Evaluation of NuScale Post ECCS Actuation Boron Dilution Events

Revision 1.

**Division of Safety Systems
Office of Nuclear Reactor Regulation**

July 6, 2020

Figure 2. Gaps of NuScale Design and Analyses Related to Boron Dilution Phenomenon

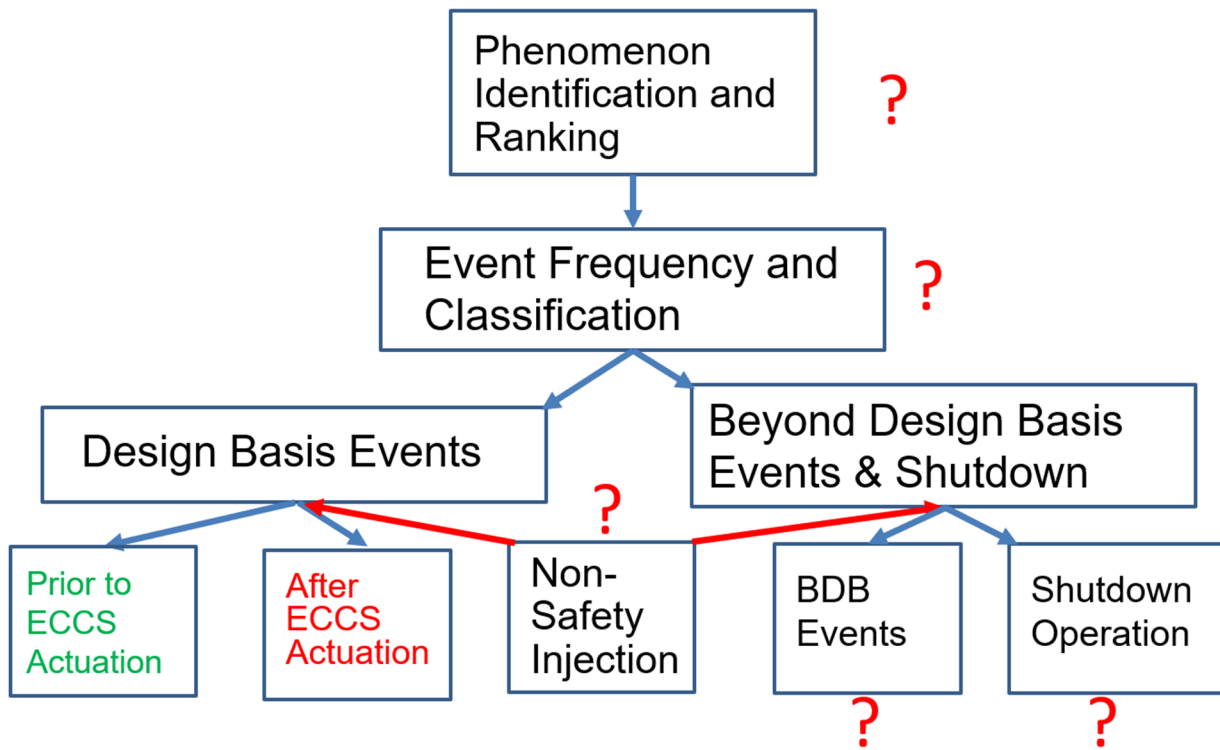
For the post ECCS actuation scenarios up to 72 hours, the NuScale's response to RAI 8930 documented its boron dilution analyses. As shown in Figure 2, several hours after ECCS actuation, most of the boric acid in the downcomer, water volume above RRV in the containment and the lower plenum has been flushed to the core and lower riser water volume. The boron concentration in these volumes is close to zero. The difficult question is how much of the mixing is between the lower riser and the core. NuScale's methodology assumed that [[]]. Therefore, according to them, there would not be any dilution in the core region. The staff performed sensitivity studies on the mixing between the core and the lower riser by dividing the core and lower riser into two separate volumes. The author assumed 95% of the boil off fluid mass coming back from the lower riser fluid volume with high boron concentration. The result shown the reactor becomes critical with one stuck rod within about 9 hours and with all rods in about 20 hours. This type of uncertainty was indeed not tolerable as there was no relevant experimental data to justify NuScale's [[]] assumption. From author's view, there should be mixing between the core and the lower riser fluid volume. However, the [[]] assumption is non-conservative.

Figure 3. NPM Post ECCS actuation Fluid Volume and Boron Concentration Distribution.

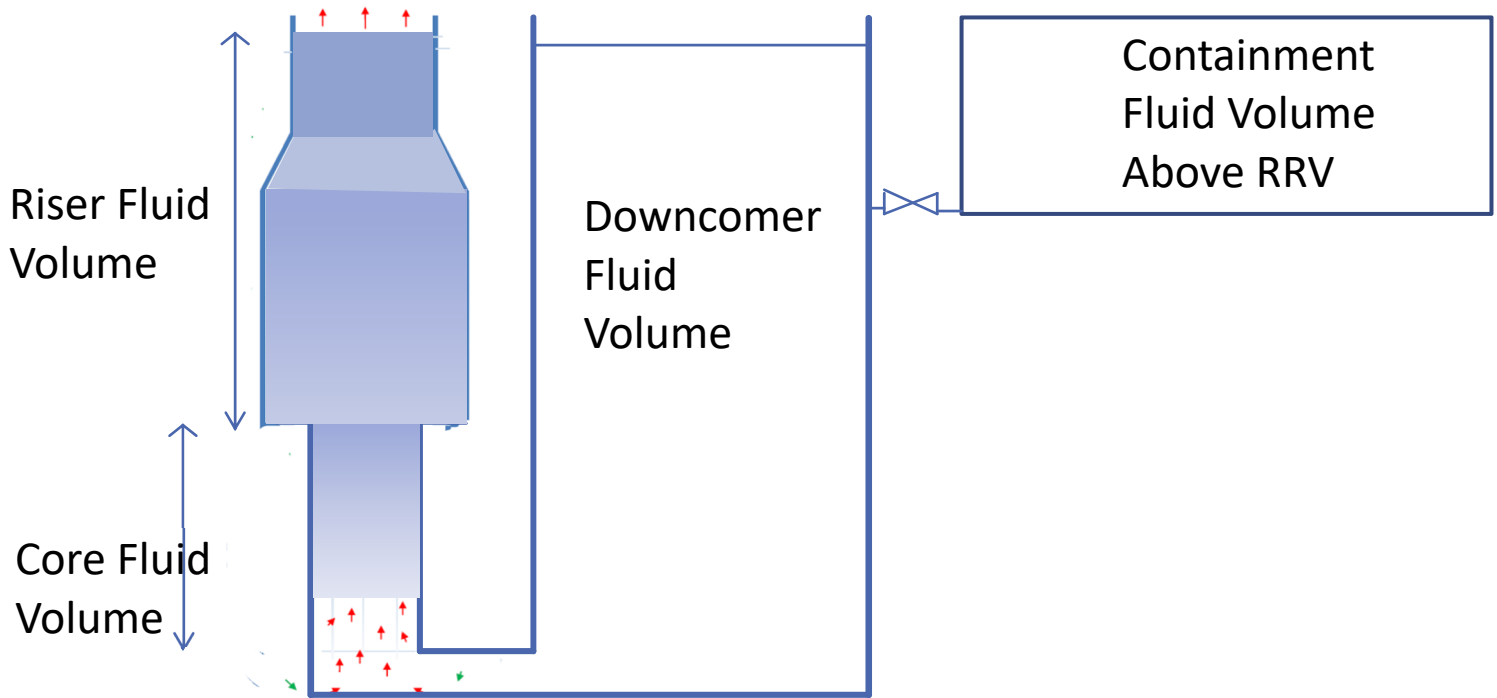
As it is shown in Figure 3, NuScale module has a very unique fluid volume distribution. From the perspective of maintaining core collapsed water level during ECCS operation, there is an ample margin. For boron transport, after the ECCS actuation, the downcomer and lower plenum becomes diluted quickly. The system becomes an "unstable" boron distribution pattern with a relatively small core fluid volume and [[]] more fresh or diluted water in the lower plenum, downcomer and the containment ready to move into the core. Any system disturbances, such as non-safety system injections, manometer type of oscillation or flow instability may have a good chance to turn the unstable steady state into a transient with a large amount of fresh water getting into the core.

Figure 4. VERRA Test Facility and Its Relevance to NuScale Boiling Length Calculation

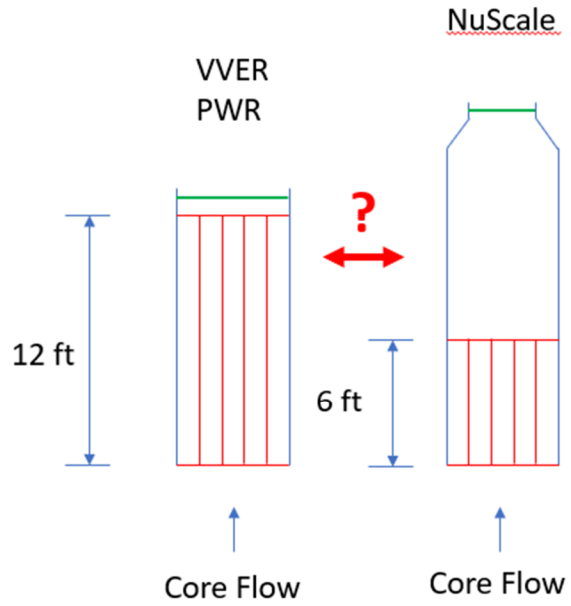
The Finish VEERA test facility was designed to measure boric acid concentration distribution during the VVER (PWR) boron precipitation scenario. Figure 4 shows the test facility and a simple relevance drawing of the facility. VERRA test facility has a 12 ft bundle with only about 0.1 meter of water on top of the bundle. NuScale has 10 ft water above the core with a core height of 6 ft. Because of this mismatch, the author expects that NuScale has longer diluted non-boiling region than what was measured in VERA. Therefore, the use of VERA test data to determine the NuScale non-boiling length is non-conservative

Figure 5. German Boron Volatility Test Facility For BWR ATWS Application

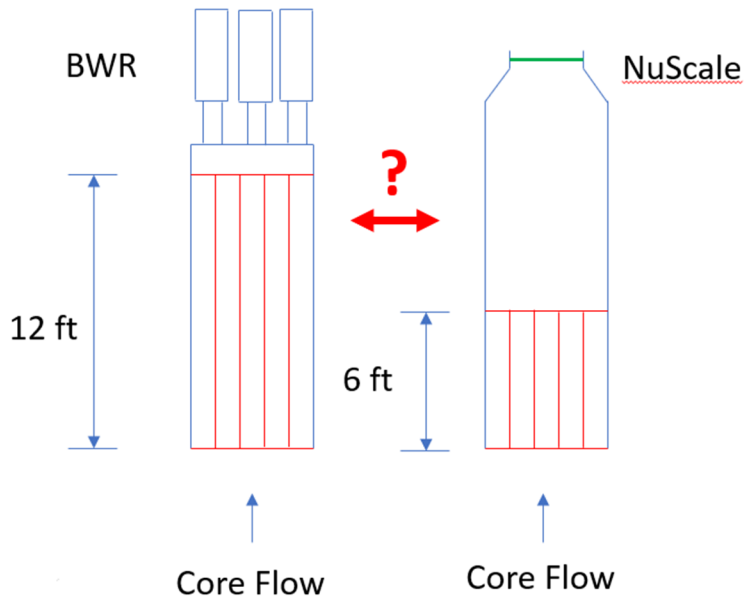
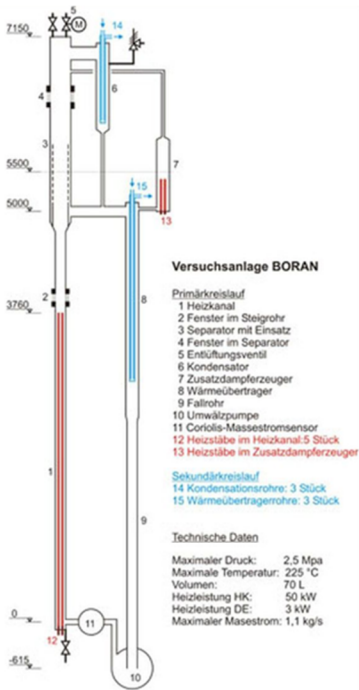
Volatility plays a gradually significant role with a time span beyond 10 hours. As shown in Figure 5, NuScale adopted a German correlation developed for BWR ATWS SLC injection scenario. The heated section has a height of 12 ft and the mass flow rate is close to 100 times more than NuScale boil off rate. Not only the test was not scalable to NuScale condition, but also the correlation predicted much lower value than both WAPD data and 1999 Chemical Thermodynamic Journal data by a factor of 2.0 (Figure 6). The staff also performed sensitivity analyses and predicted the return to power within 72 hours once other volatility correlations are used.
